SUNDRY NOTICES AND REPORTS ON WELLS (DO NOT USE THIS FORM FOR PROPOSALS TO DRILL OR TO DEEPEN OR PLUG BACK TO A DIFFERENT RESERVOIR. USE "APPLICATION FOR PERMIT" (FORM C-101) FOR SUCH PROPOSALS.)		WELL API NO. 30-015-43806

2. Name of Operator MESQUITE SWD, INC.		6. State Oil & Gas Lease No. FEDERAL
3. Address of Operator PO BOX 1479 CARLSBAD NM 88220		7. Lease Name or Unit Agreement Name UBER EAST SWD

Proposed Well Bore Diagram
Revised 07/11/2018

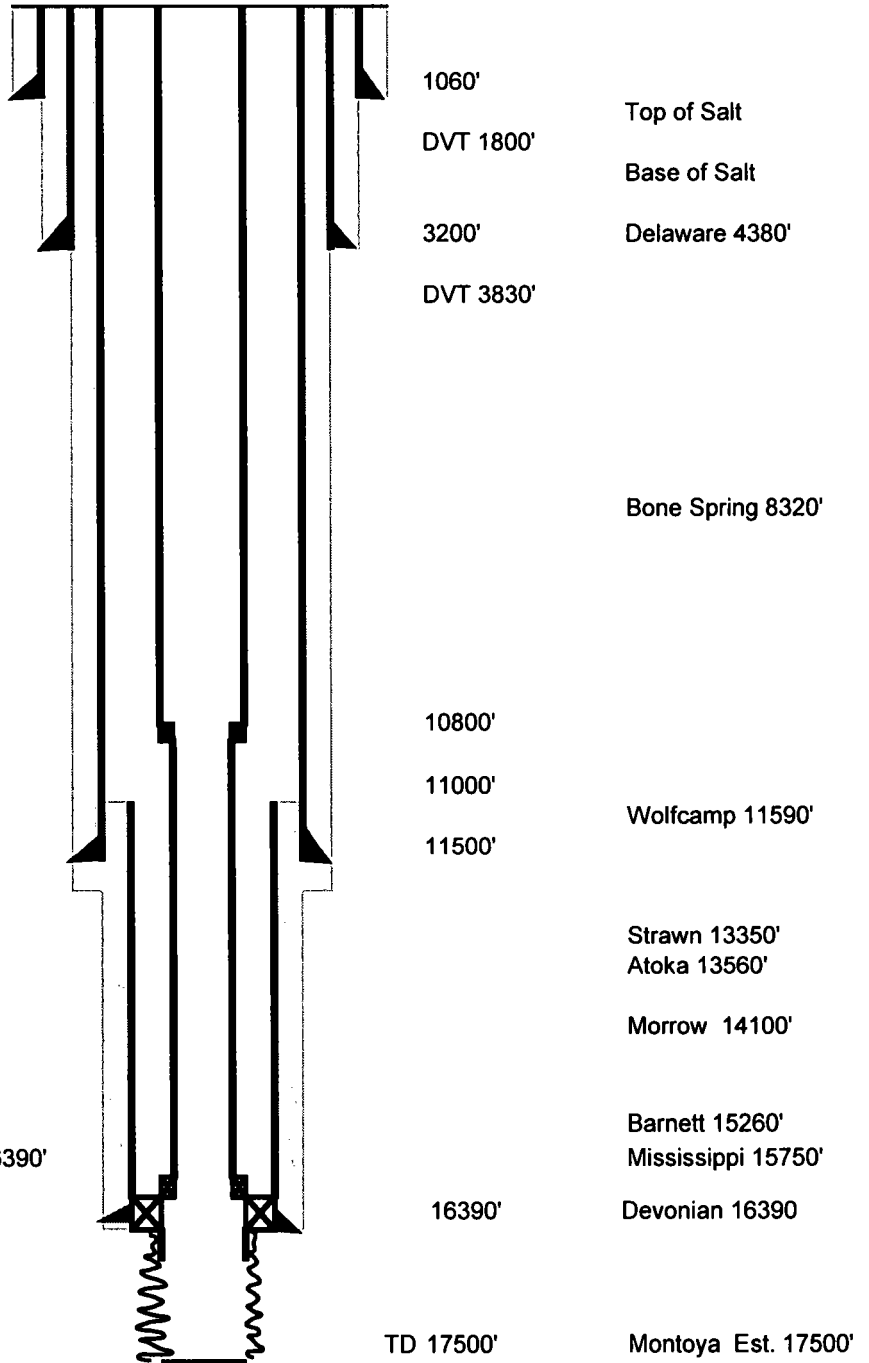
Mesquite SWD, Inc. requests permission to run a tapered tubing string in this well. We propose To run 7" tubing inside the surface and intermediate hole and 5 1/2" tubing inside the liner. Revised proposed well bore diagram is attached.

7" 26# P-110 Tbg @ 10795'
7" x 5 1/2" X-Over @ 10800'
5 1/2" 20# JFE Bear Tbg @ 16385"
7 5/8" x 5 1/2" Dual Bore Permapak Packer @ 16390'
